UNITED STATES PATENT AND TRADEMARK OFFICE

APPLICATION NO.	FILING DATE	FIRST NAMED INVENTOR	ATTORNEY DOCKET NO.	CONFIRMATION NO.
10/036,305	12/28/2001	Jang-Kun Song	8071-4 (OPP 010597US)	2751
7590	10/10/2003		EXAMINER	
F. CHAU & ASSOCIATES, LLP Suite 501 1900 Hempstead Turnpike East Meadow, NY 11554			RUDE, TIMOTHY L	
			ART UNIT	PAPER NUMBER
			2871

Office Action Summary	Application No.	Applicant(s)	
	10/036,305	SONG ET AL.	
	Examiner Timothy L Rude	Art Unit 2871

DETAILED ACTION

FIG. 3C

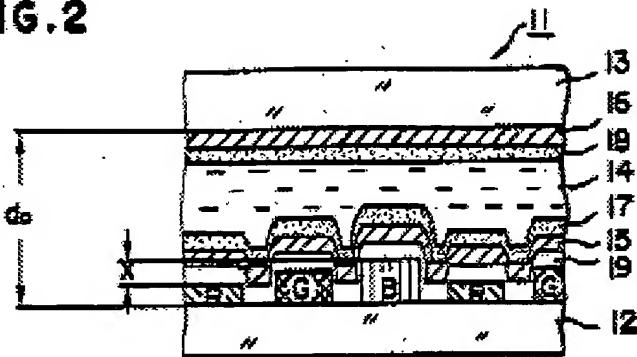
As to claim 1, Kim discloses in Figure 3C a liquid crystal display comprising: a first insulating substrate, 31; a gate line, 1 (Applicant's first wiring line), assembly formed on the first insulating substrate with a plurality of first wiring lines; a data line, 3 (Applicant's second wiring line) assembly crossing over the first wiring line assembly

with a plurality of second wiring lines while defining pixel regions (col. 3, lines 20-65), the second wiring line assembly being insulated, 35, from the first wiring line assembly; a pixel electrode, 13, formed at each pixel region with a first opening pattern; a thin film transistor (col. 3, lines 48-51) connected to the first wiring line assembly, the second wiring line assembly, and the pixel electrode; a second insulating substrate, 33, facing the first insulating substrate; color filters, 23, of red, green and blue formed on the second insulating substrate; a common electrode, 17, formed on the second insulating substrate with the color filters having a second opening pattern; and a liquid crystal layer (col. 3, lines 61-62) sandwiched between the first and the second insulating substrates with liquid crystal molecules, the liquid crystal molecules of the liquid crystal layer being vertically aligned (col. 6, lines 17-45) with respect to the, first and the second substrates when no electric field is applied between the pixel electrode and the common electrode.

FIG.2

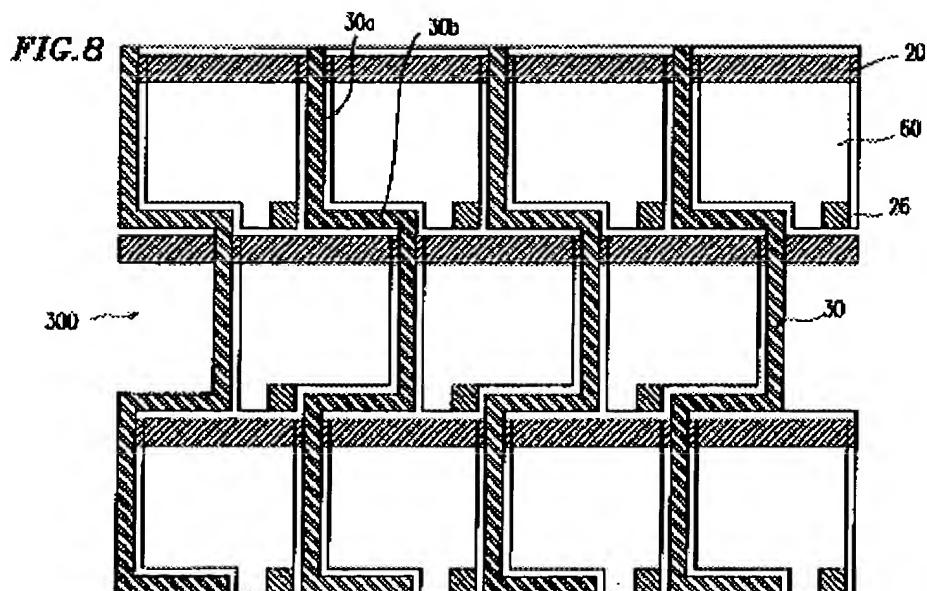
Takao teaches a display in Figure 2 wherein a B cell gap is differentiated from an R cell gap or a G cell gap, the R cell gap indicates the thickness of the liquid crystal layer at the region of the red color filter, the G cell gap indicates the thickness of the liquid crystal layer at the region of the green color filter, and the B cell gap indicates the thickness of the liquid crystal layer at the region of the blue color filter in order to adjust the desired spectral characteristics (col. 5, line 35 through col. 7, line 7, especially col. 5, lines 46-49).

Takao is evidence that ordinary workers in the art of liquid crystals would find the reason, suggestion, or motivation to add a B cell gap that is differentiated from an R cell gap or a G cell gap, the R cell gap indicates the thickness of the liquid crystal layer at the region of the red color filter, the G cell gap indicates the thickness of the liquid crystal layer at the region of the green color filter, and the B cell gap indicates the thickness of the liquid crystal layer at the region of the blue color filter in order to adjust the desired spectral characteristics.
